The Commission has issued the enclosed Amendment No.53 to Facility Operating License No. NPF-2 and Amendment No. 44 to NPF-8 for the Joseph M. Farley Nuclear Plant, Unit Nos. 1 and 2, respectively. The amendments consist of changes to the Technical Specifications in response to your application transmitted by letter dated May 14, 1984.

The amendments change the Technical Specifications in Section 6, Administrative Controls, to reflect changes in the title of the Vice President Nuclear Generation to be Senior Vice President and to eliminate the former management position.

JOSEPH M. FARLEY NUCLEAR PLANT, UNIT NO. 1

ATTACHMENT TO LICENSE AMENDMENT NO. 53  
AMENDMENT NO. 53 FACILITY OPERATING LICENSE NO. NPF-2  
DOCKET NO. -50-348

Figure 6.2-1 Offsite Organization for Facility Management and Technical Support

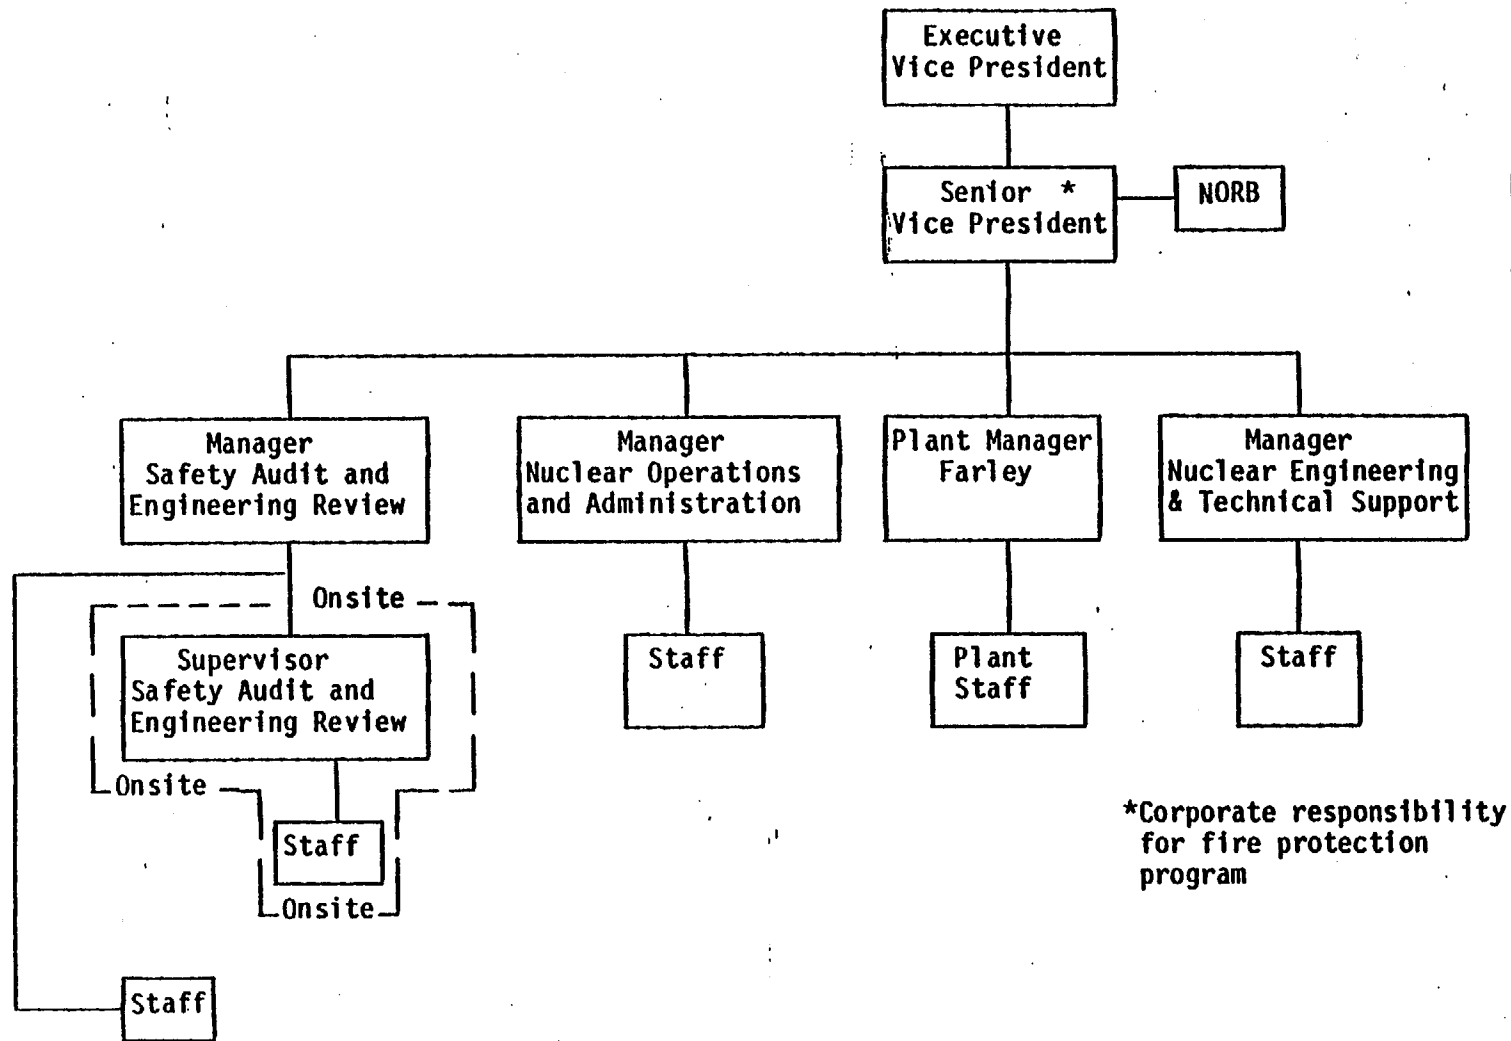
6.2.1 The offsite organization for facility management and technical support shall be as shown on Figure 6.2-1.

Figure 6.2-1 Offsite Organization for Facility Management and Technical Support

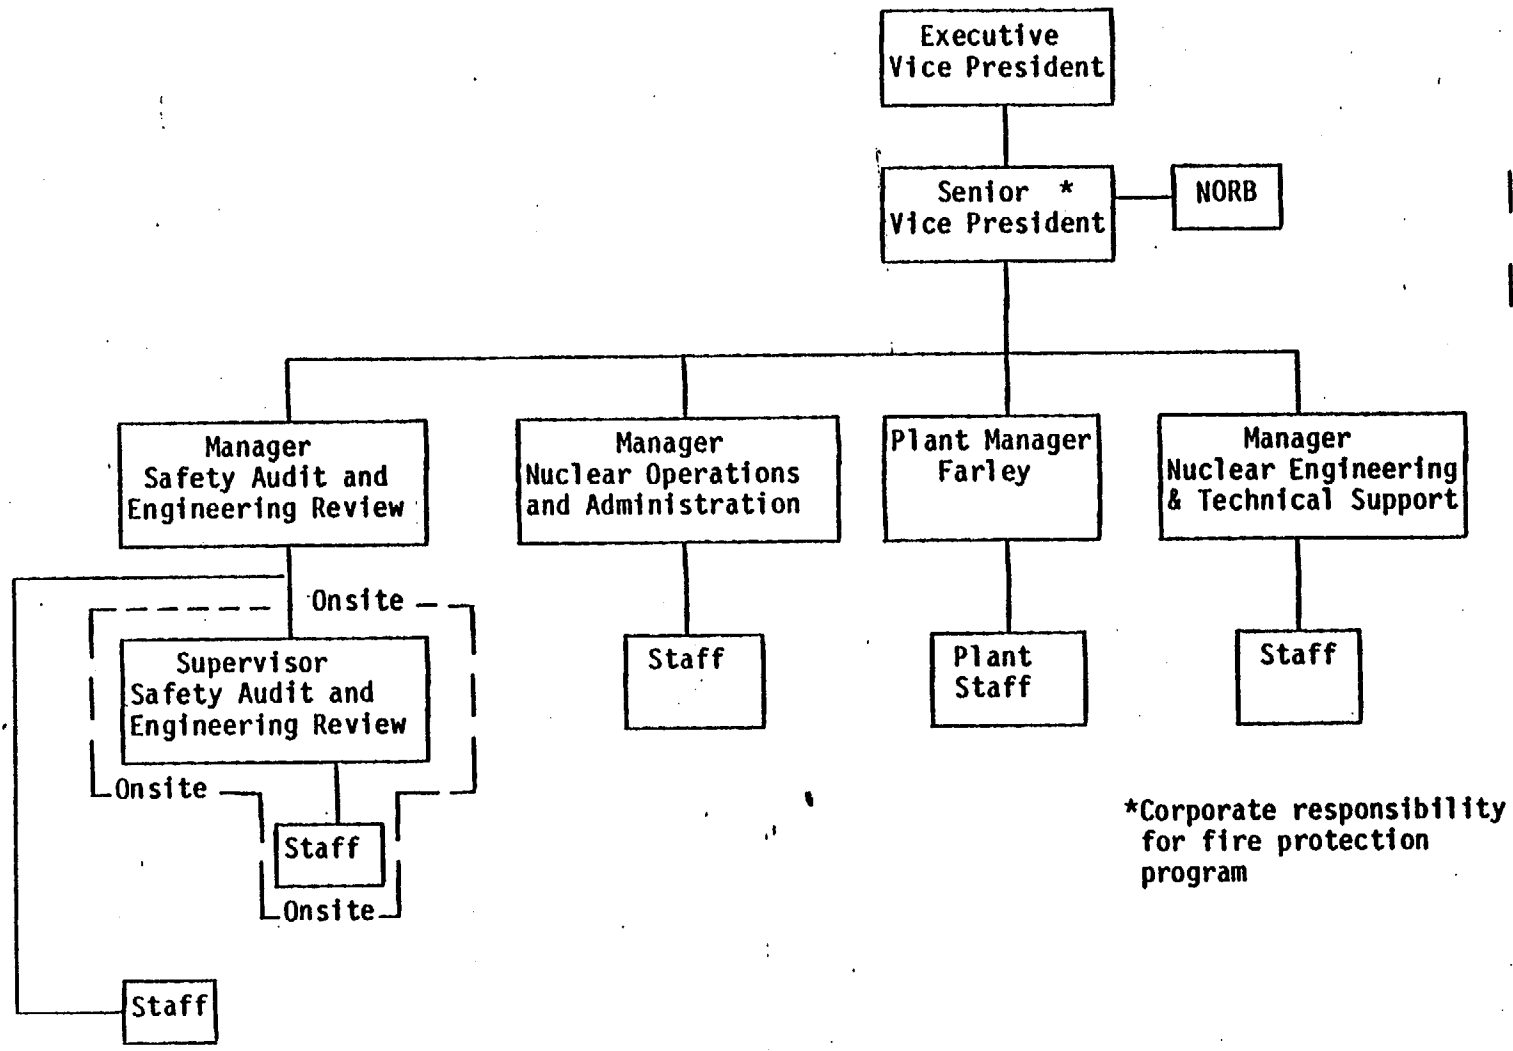
6.2.1 The offsite organization for facility management and technical support shall be as shown on Figure 6.2-1.
